PRE-GATEWAY REVIEW – Information Assessment and Recommendation Report

Local Governmental Area:	Ryde	
Amended LEP:	Ryde Local Environmental Plan 2014	
Address:	86 Blenheim Road and 12-14 Epping Road, North Ryde	
Reason for review:	☒ Council notified proponent it will not support proposed amendment	☐ Council failed to indicate support for proposal within 90 days
Is a disclosure statement relating to reportable political donations under s147 of the Act required and provided?	☒ Provided	☐ N/A Comment: There are no donations or gifts to be disclosed.
Assessment Fee:	☒ Provided & correct	☐ Not provided / incorrect

Figure 3: Existing Built form, Current and Proposed zoning controls.

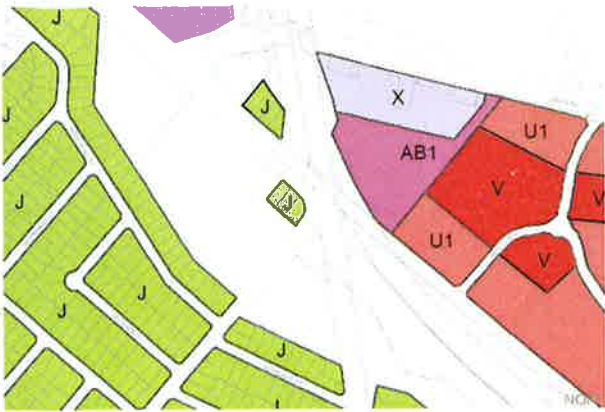
Council argues there is a lack of urban design rationale to justify the excessive height and FSR, the visual bulk when viewed from the adjacent low density residential area and the inconsistency with other similar developments approved by the State Government on the southern side of Epping Road.

The proposed FSR of 4.3:1 far exceeds the FSR control for the adjacent low density residential land to the south and west of the site in Morshead and Clarence Streets of 0.5:1. The FSR controls for sites in the North Ryde Station UAP vary from 2:1 and 2.3:1, apart from higher densities on the major Country Gardens and Lachlan's Line sites which are up to 3.5:1, other than one small portion of the Lachlan's Line site which has an FSR control of 4.3:1.

Figure 5: Existing Built form, Current and Proposed floor space ratio controls.

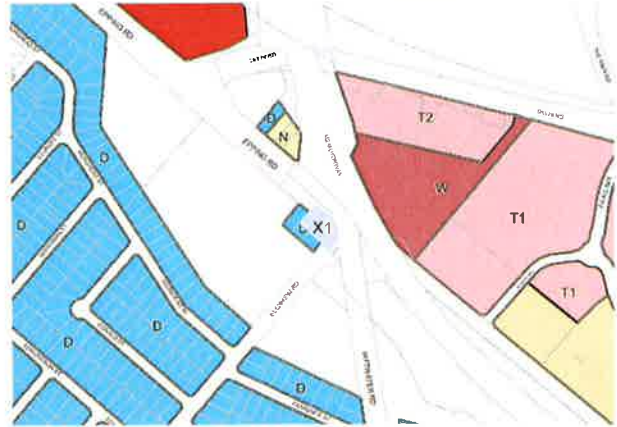
- The proposed floor space ratio of 4.3:1 does not appear to align with the proposed height in so far as the submitted preliminary development analysis drawings reflect more than the 8,619 square metres of floor space. This is due to different suggestions of the combined sites area by Council and the proponent.

- reduce the proposed building height for the site to enable a more appropriate built form and transition from the surrounding low density residential and open space areas to the commercial precinct north of Epping Road; and
- reduce the proposed maximum FSR to reflect the considerable decrease to the built form.

Figure 10: Proposed built form. Source: Grimshaw Architects 2015

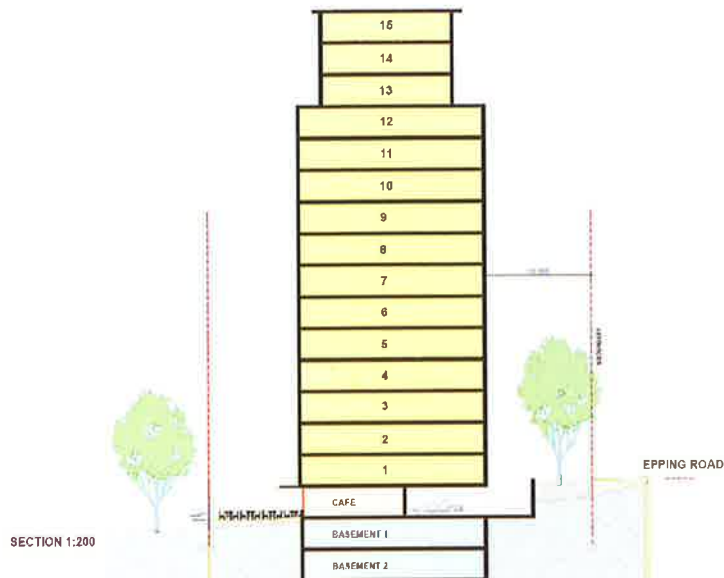
The Department supports an increase in the maximum building height and FSR for the site as it will provide additional housing and greater housing choice in the Macquarie Park Strategic Centre and near public transport options. This will assist in achieving the strategic direction of the North Subregion in *A Plan for Growing Sydney*, as it will provide additional housing near employment, education and transport services.

The proposal notes that the nearest residential neighbour to the site is 135 metres away and therefore the edge / boundary impacts typically associated with a rezoning for greater height and FSR are not a factor in this proposal. The Department does not support the proposed height and FSR as the proposal's interface with Blenheim Park and the adjoining low density residential area south of Blenheim Park has not been fully considered by the proposal.

The Department recommends the Panel considers the recommendations of the approved Part 3A developments in Allengrove Crescent and Whiteside Street/David Avenue, North Ryde which resulted in developments of 5-6 storeys, when considering the maximum building height for the site. Another relevant consideration is Council's invitation to the proponent to submit a 7 storey redevelopment proposal. Reducing the proposed building height and FSR would provide a more appropriate interface to Blenheim Park, whilst maintaining the amenity of the existing low residential density area south of Blenheim Park.

When considering previously approved Part 3A developments south of Epping Road, the Planning Assessment Commission noted that Epping Road acts as a boundary between the low density residential area in North Ryde and the higher density of Macquarie Park. Should the proposal proceed to Gateway, the proposed building height should be more consistent with the surrounding built form and function as a transitional building to the higher densities on the opposite side of Epping Road.
